**RE:** Staff Recommendations for the June 4, 2026 Public Hearing

**WAIVER:** W-26-0001

**REQUEST FOR ACTION:** Applicant is requesting a waiver to Detail #24/24b located in Appendix A of the Kenton County Subdivision Regulations which details the geometric design requirements for cul-de-sac and multifamily turn-around streets. Granting this waiver would allow the applicant to deviate from the standard design of the cul-de-sac and multifamily turn-around streets.

Figure 2

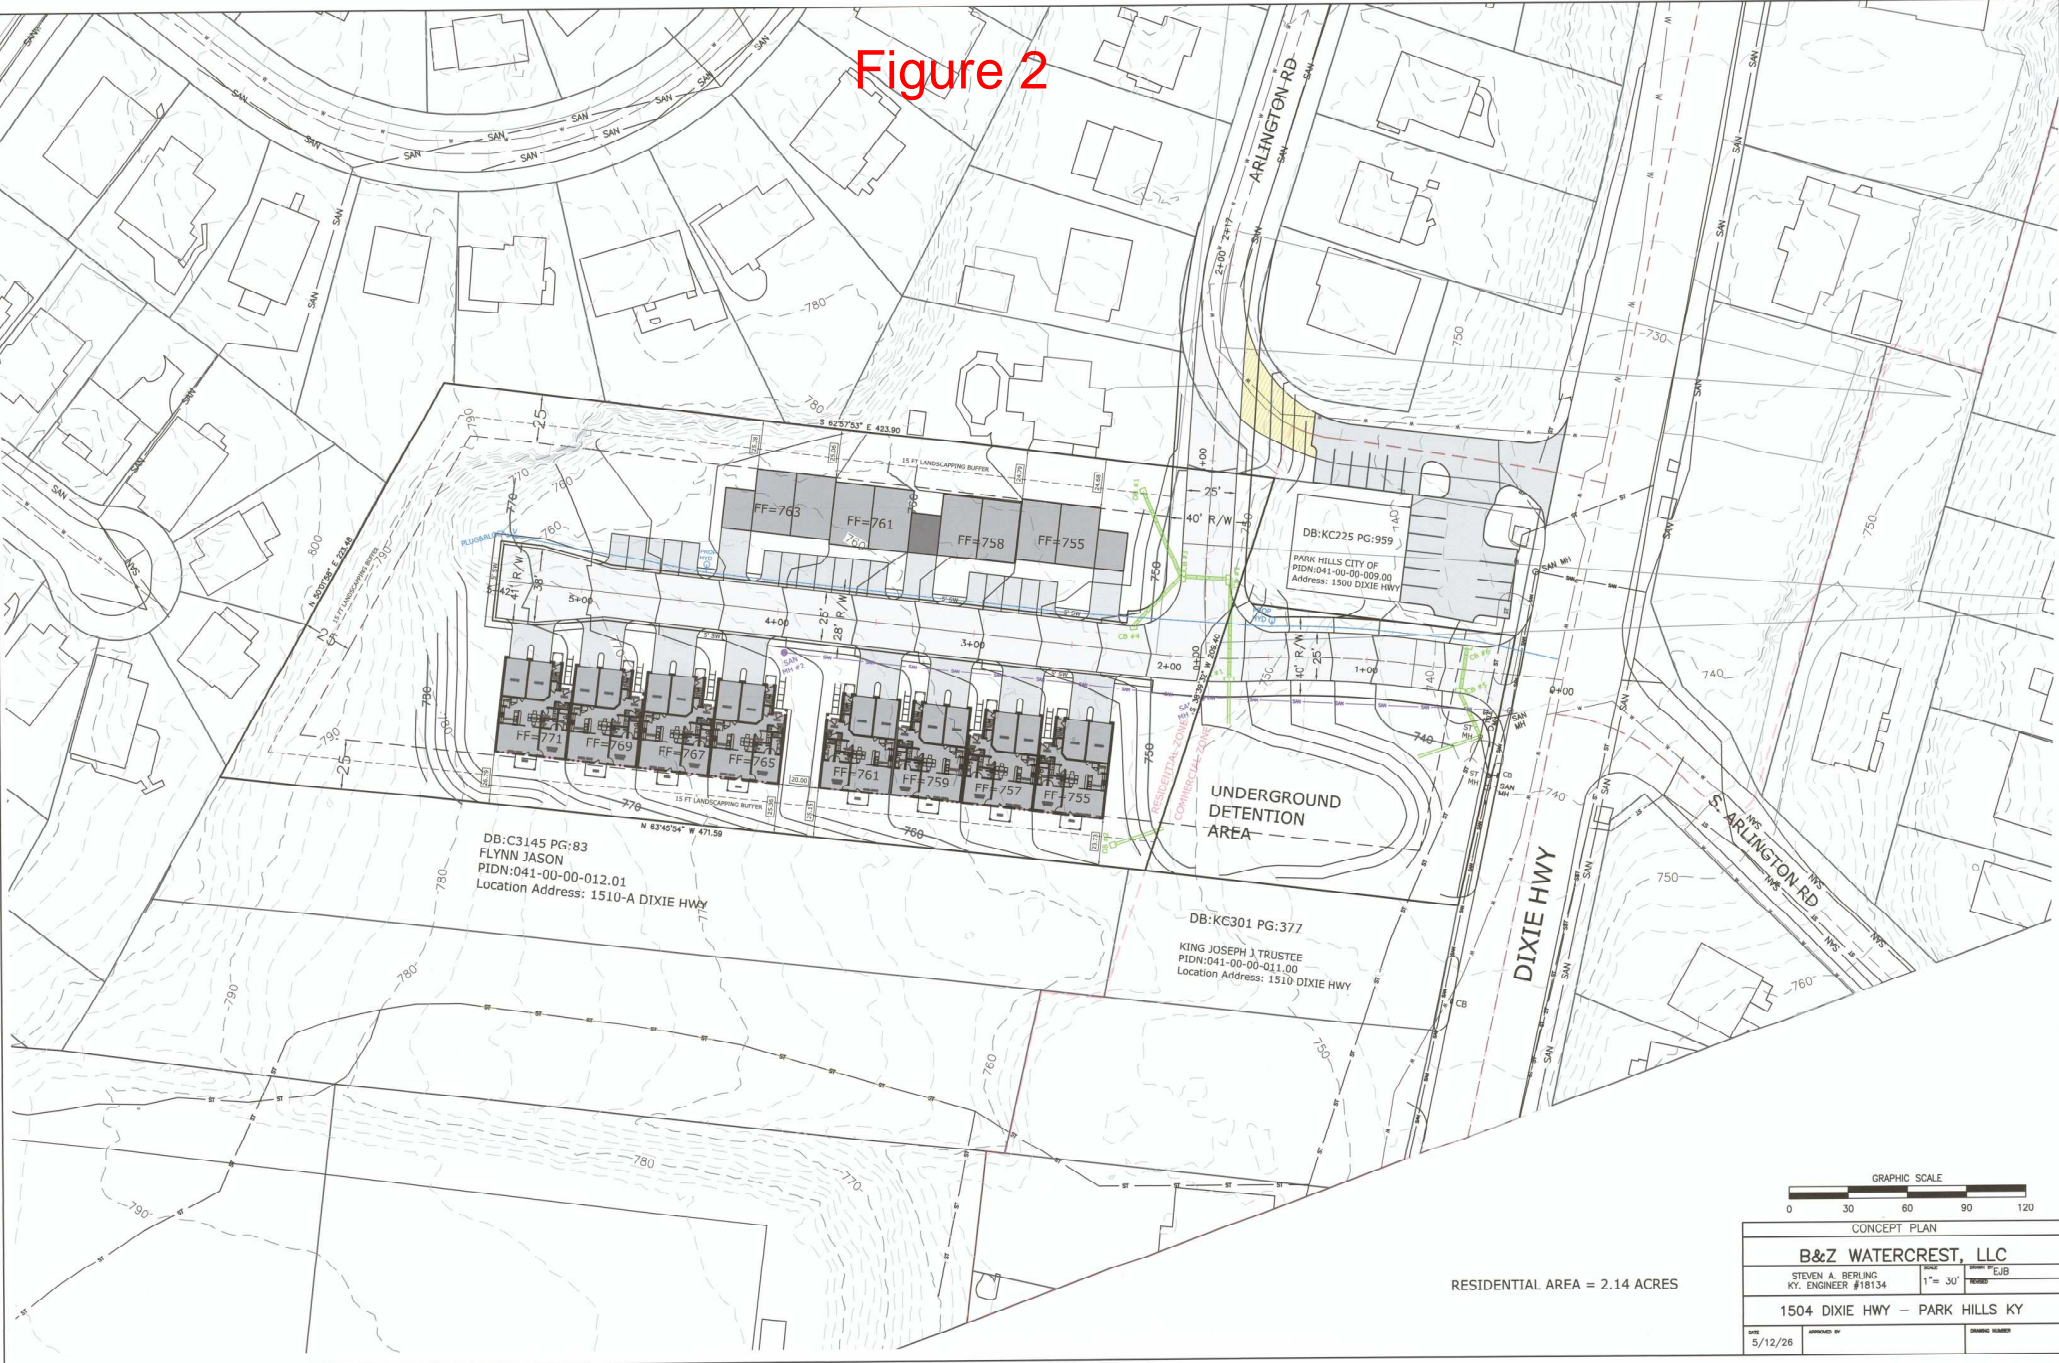
1. The subject parcel is located within the City Limits of Park Hills and consists of approximately 2.14 acres. The applicant is proposing to construct a new development consisting of 24 multifamily dwelling units, The proposed plan may be found in Figure 2.

10. The proposed street terminus will have a pavement width of 38-feet, compared to the 65-foot width of a standard cul-de-sac at its widest point and the 43-foot roadway width of a standard multifamily turnaround. The maximum right-of-way width for the proposed design is 41-feet.

11. A 4-foot-wide concrete sidewalk will be provided on either side of the street at the back of curb; sidewalk widths are not included in the right-of-way calculations.

Figure A.1-Z: Detail #24

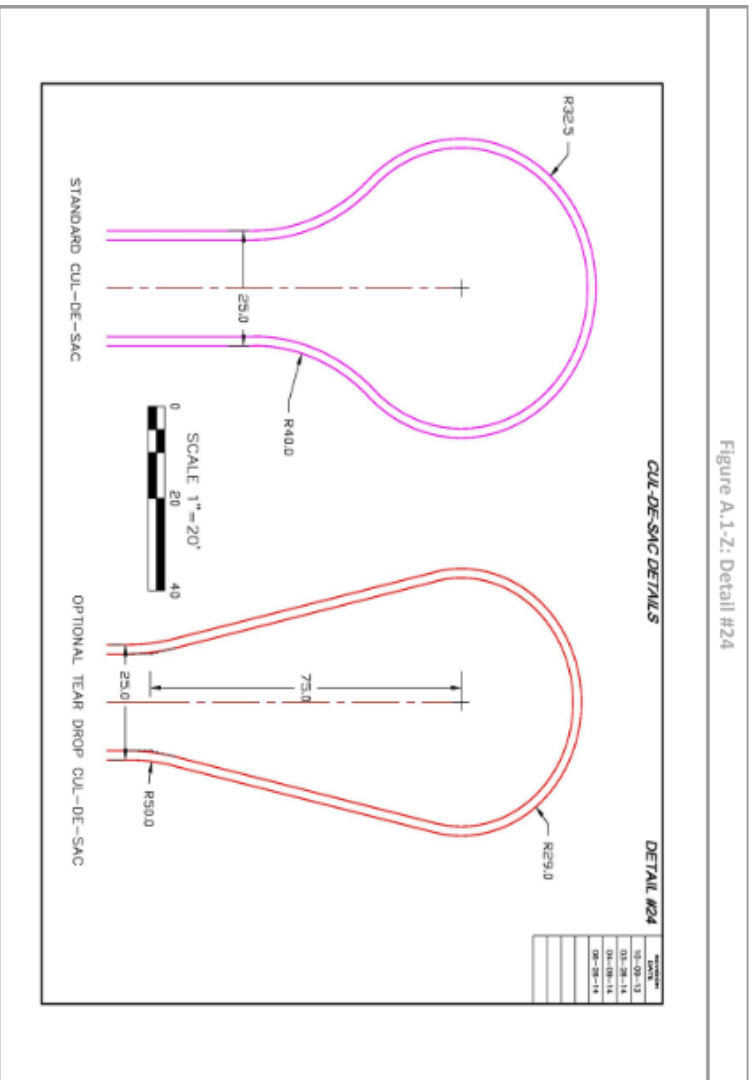
8. Appendix A of the Kenton County Subdivision Regulations, specifically Details #24 and #24b, details the geometric design requirements for cul-de-sac streets and multifamily turnarounds, see figure 3.

9. The applicant is requesting a waiver to Appendix A, specifically Details #24 and #24b. If approved, this waiver would allow the applicant to construct a non-standard street terminus within the proposed development.

Figure 4

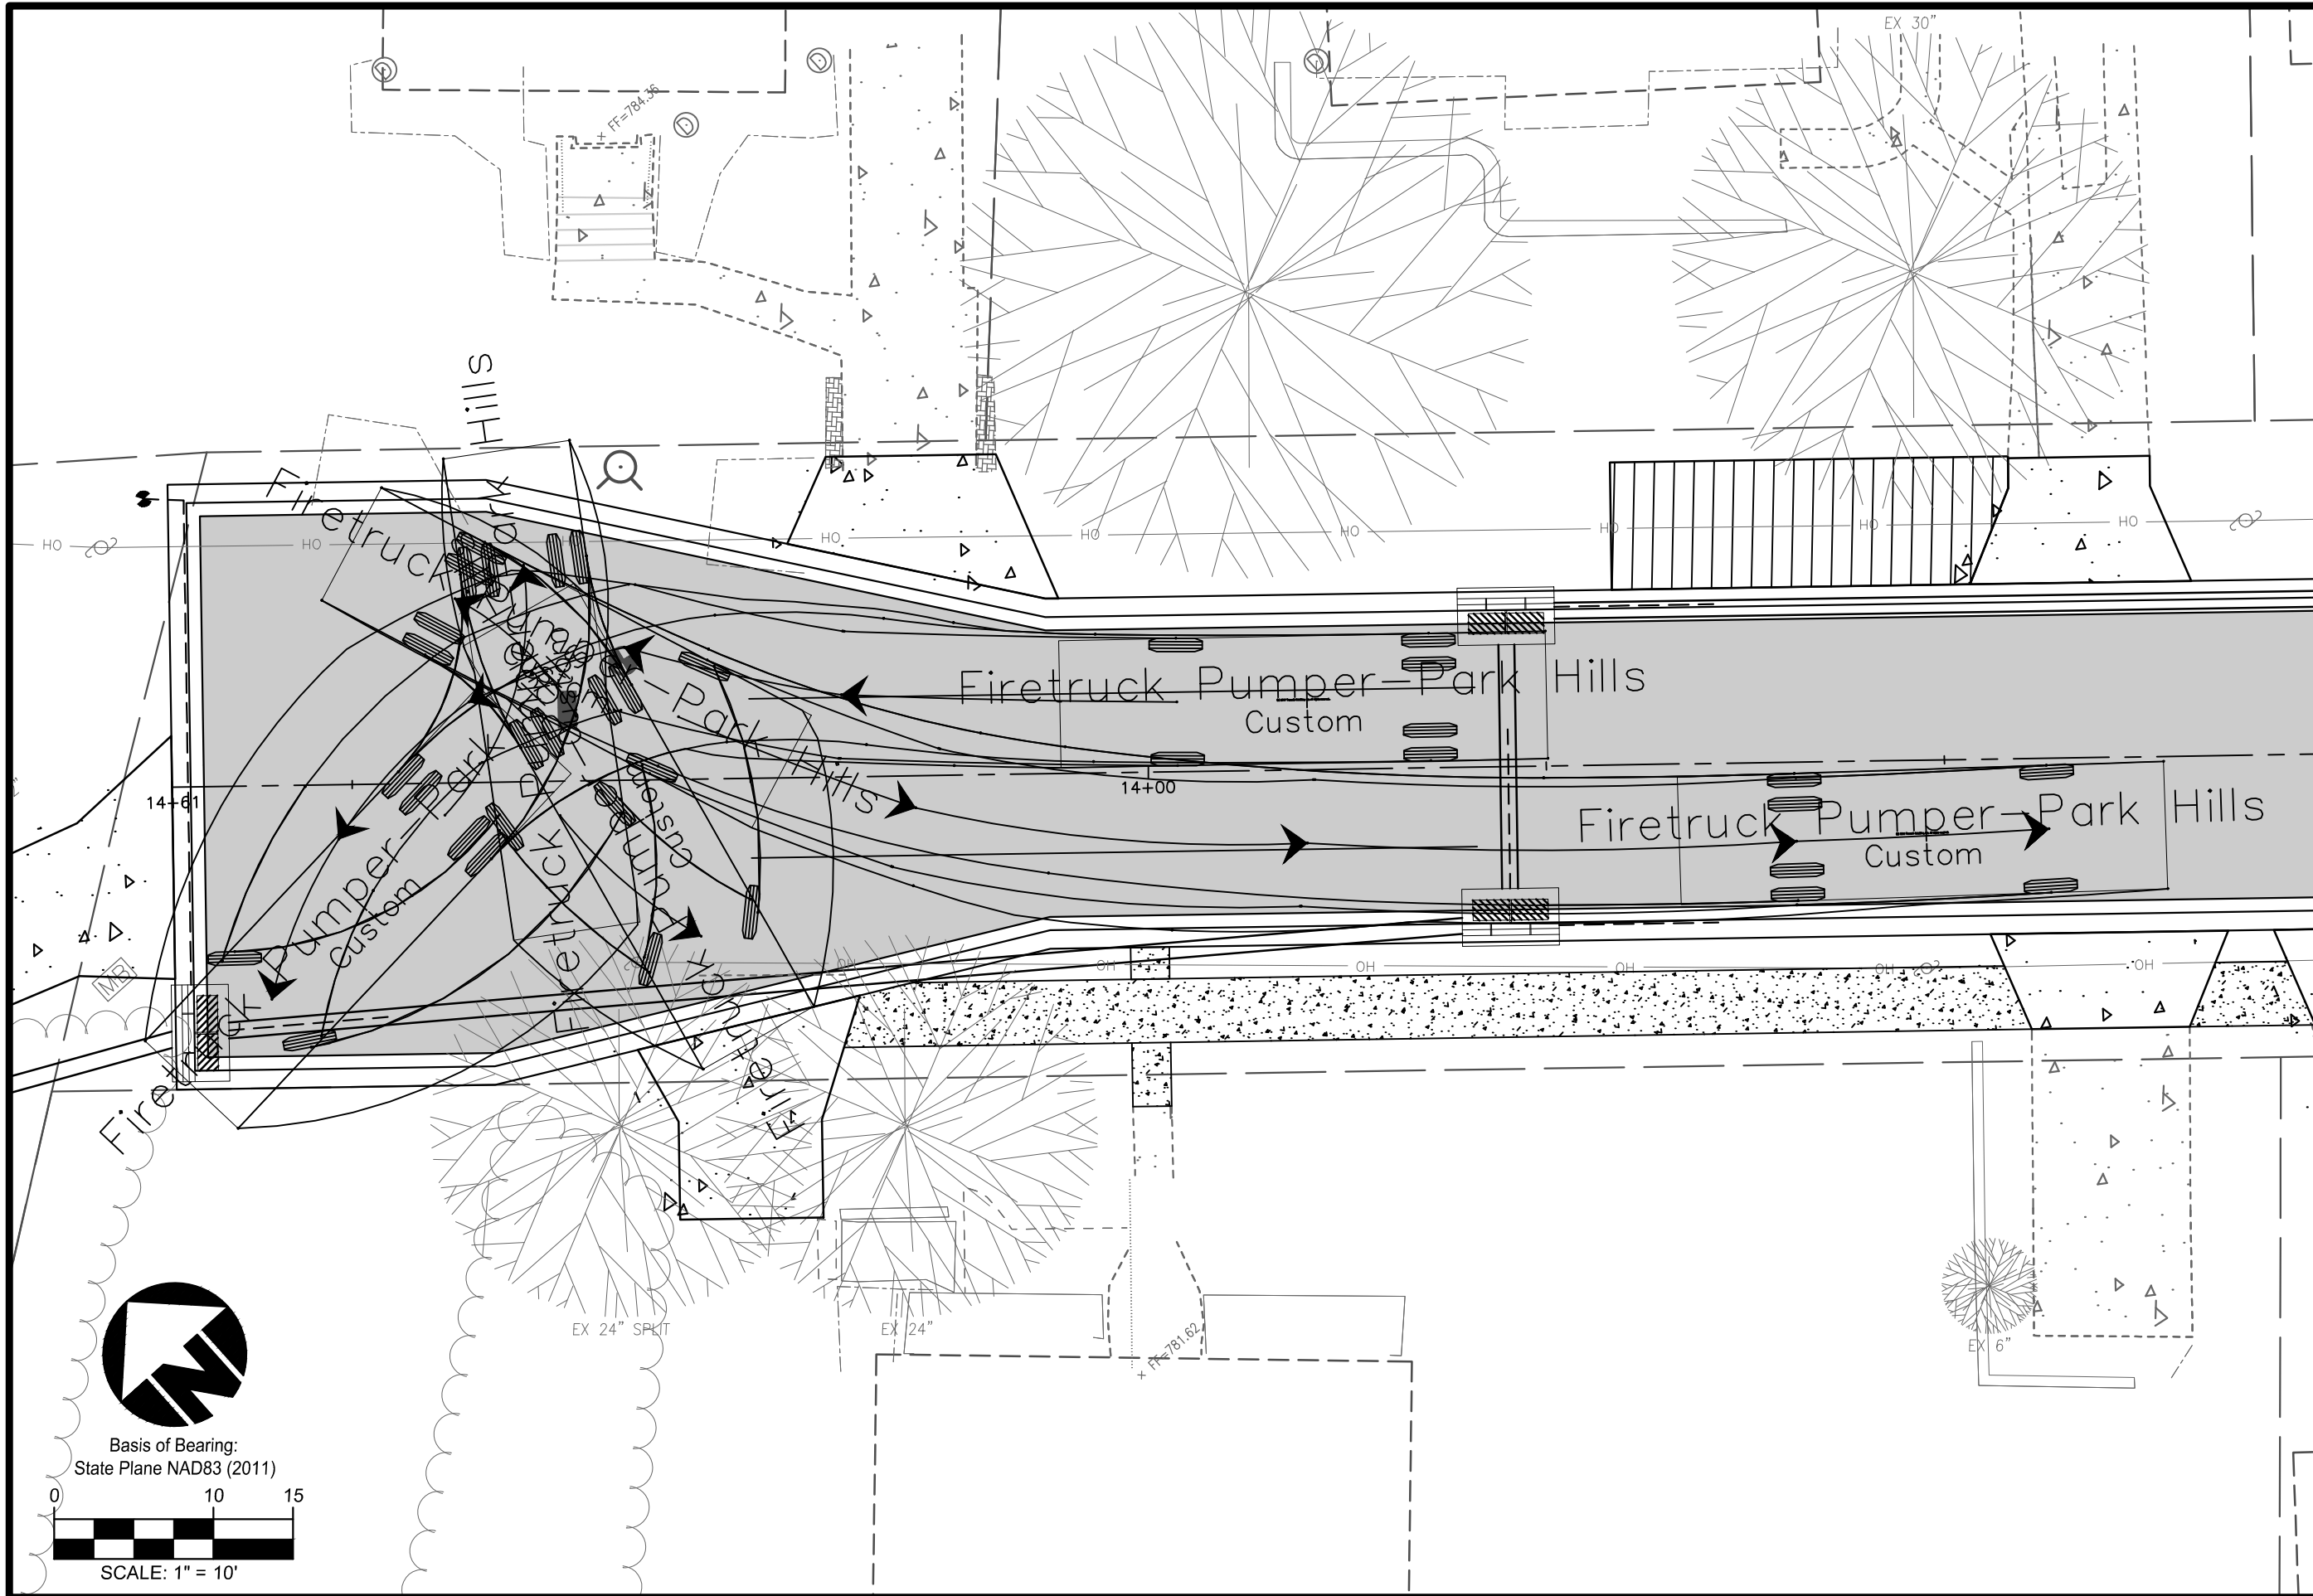
12. The Applicant has conducted the necessary analysis to confirm that a City of Park Hills Fire Truck will be able to safely maneuver a turn-around in the proposed street terminus, see figure 4.

I do not have a problem with this style of turnaround. It has proven sufficient on the end of Altavia Ave. However, I would like to see another fire hydrant installed at the new streets entrance and Dixie Hwy. The current hydrant is essential for all of the commercial occupancies on Dixie Hwy. and the distance between 1522 hydrant and Finkes Pub 1458 hydrant would be too great with the removal of Dixie and Arlington. Please let me know if you have any questions.
